35/13-06F 30 Hesketh St

Chey Chase Village Historic District, 35/13

APPLICATION FOR HISTORIC AREA WORK PERMIT

Replace single lite casement windows in 1987 rear sunroom with 6/6 double hung windows.

Front View From Hesketh Street ↑

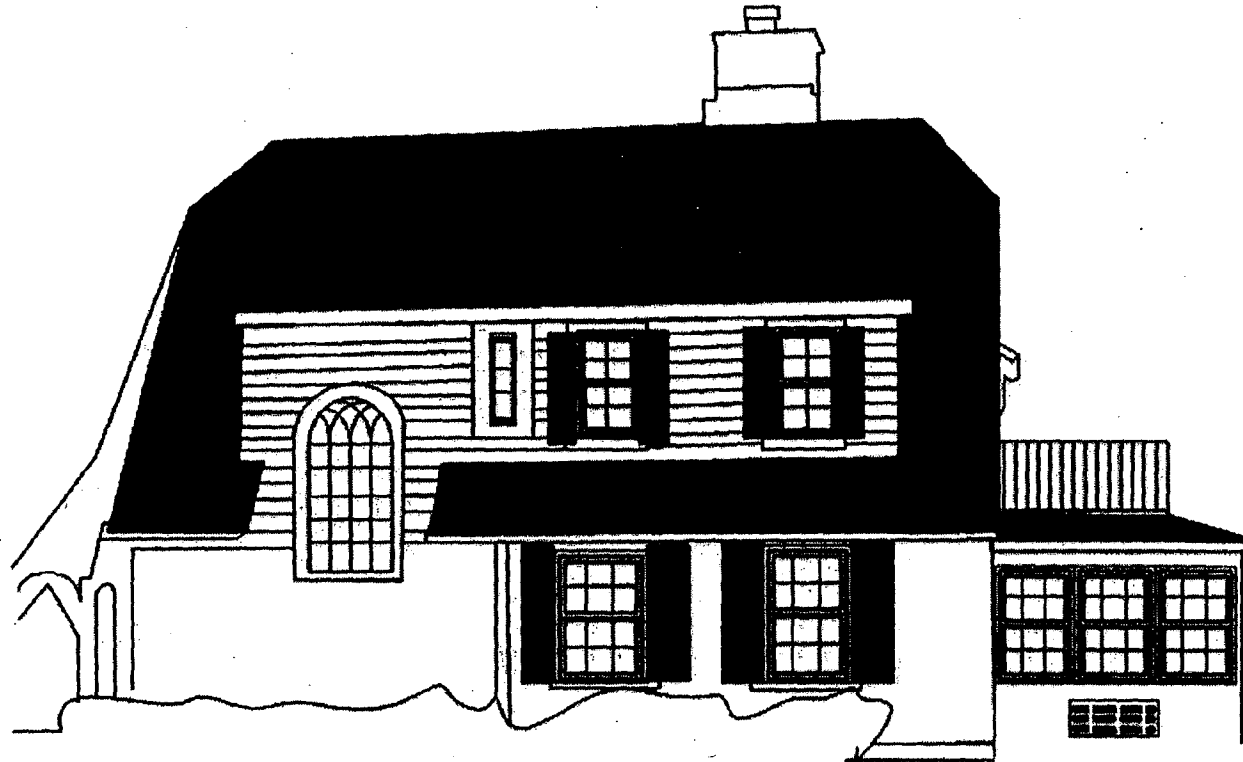
The existing window on the front façade is a vinyl replacement that is shorter than the original window opening. The new replacement window will fit the old opening, which is about 4" taller. The drawings in the application do not effectively reflect this change so staff is recommending a condition that allows for staff to ensure that the new window has a vertical appearance and is proportional to the other windows on the façade.

OK
EGT
4/26/06

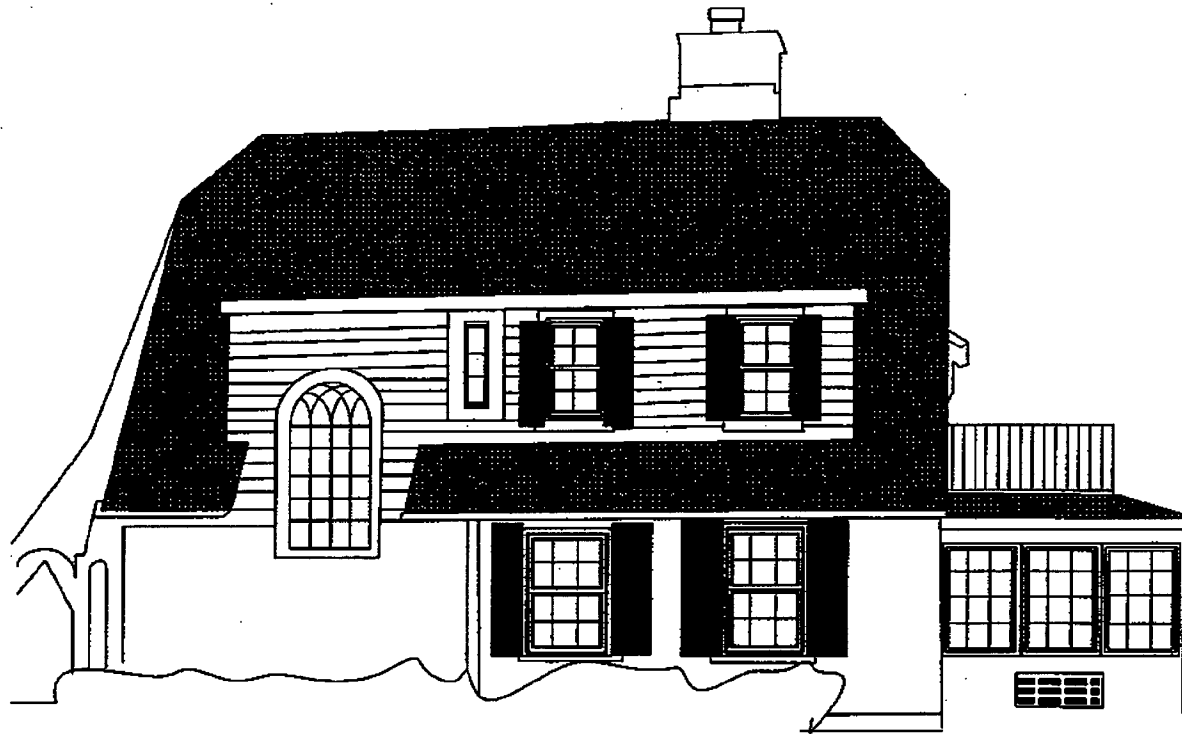
They're casements? They have the proportions of the double-hung windows originally submitted. I was expecting something more like what's on this revised drawing.

Rear View showing Sunroom

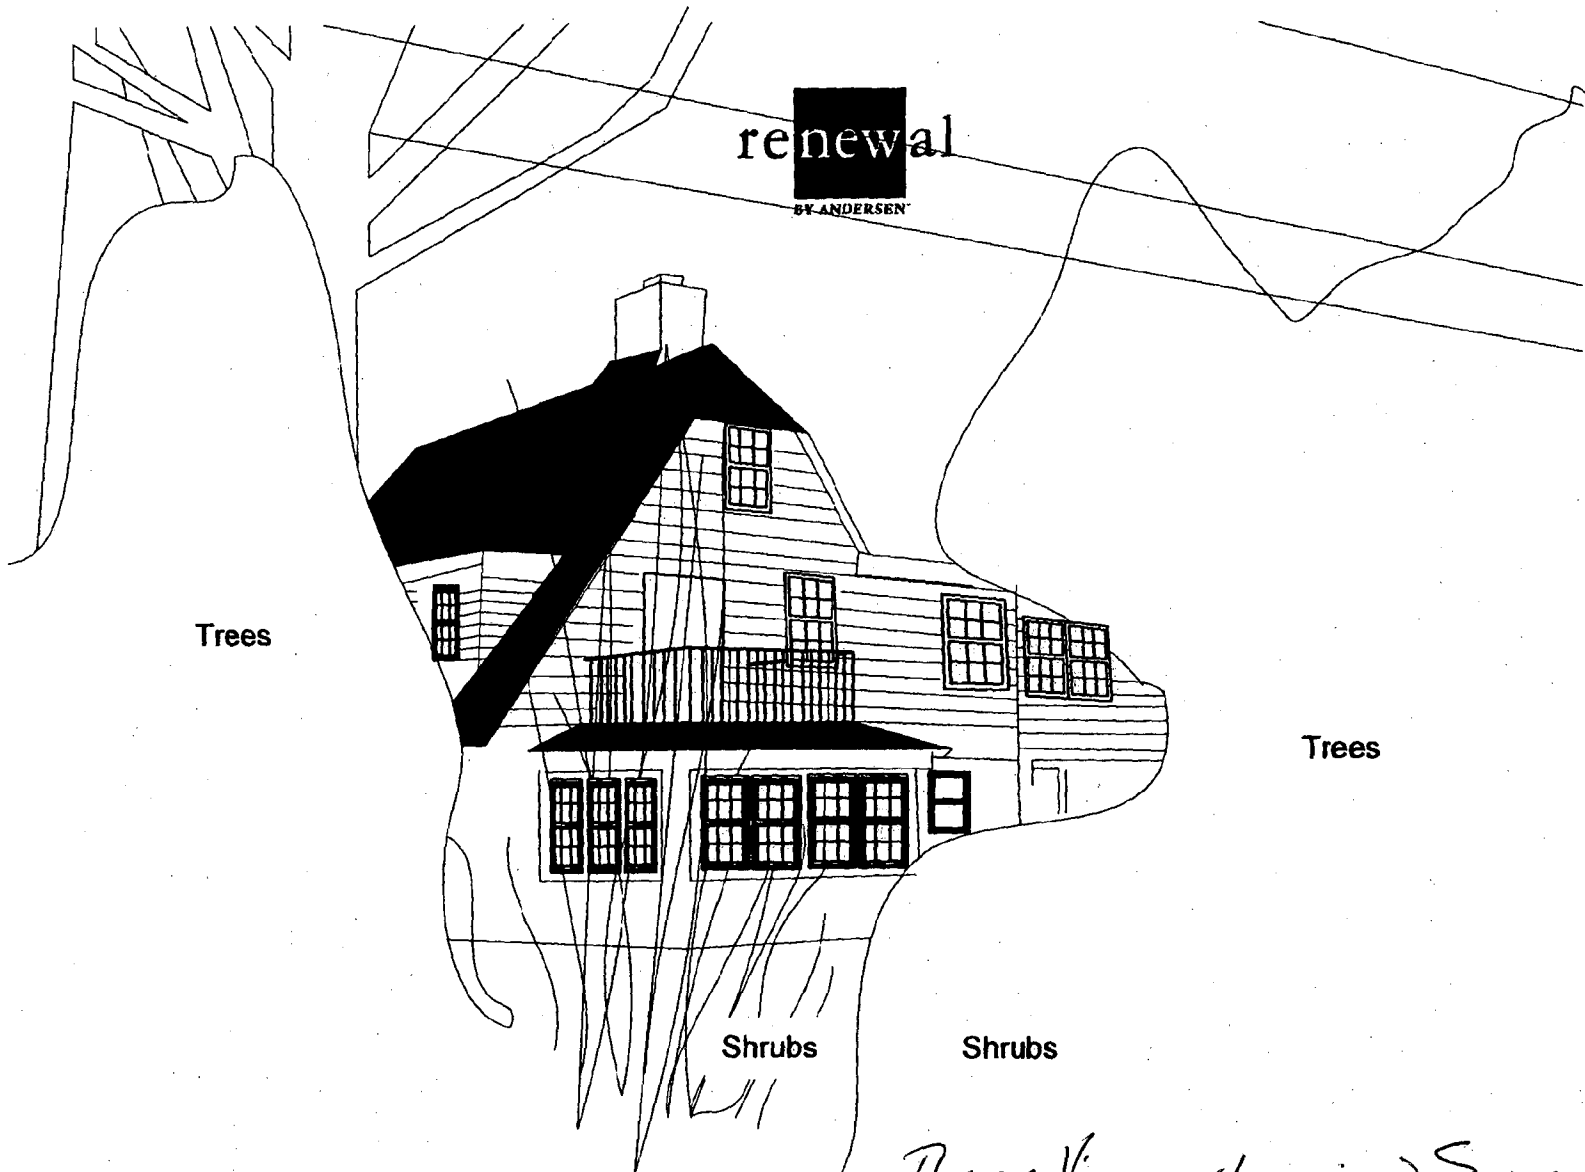
The application presents a series of 6/6 double-hung windows to replace the existing vinyl casements. Staff is recommending that the replacement windows have a glassier presentation in order to enhance the appearance of a sunroom or enclosed porch. As such, mimicking the 6/6 of the historic house may not be the most appropriate. Staff suggests that either the muntin pattern of the double-hung windows be changed or that a series of casement windows be used instead. Circle 20 shows a few examples of the openness that staff is recommending.
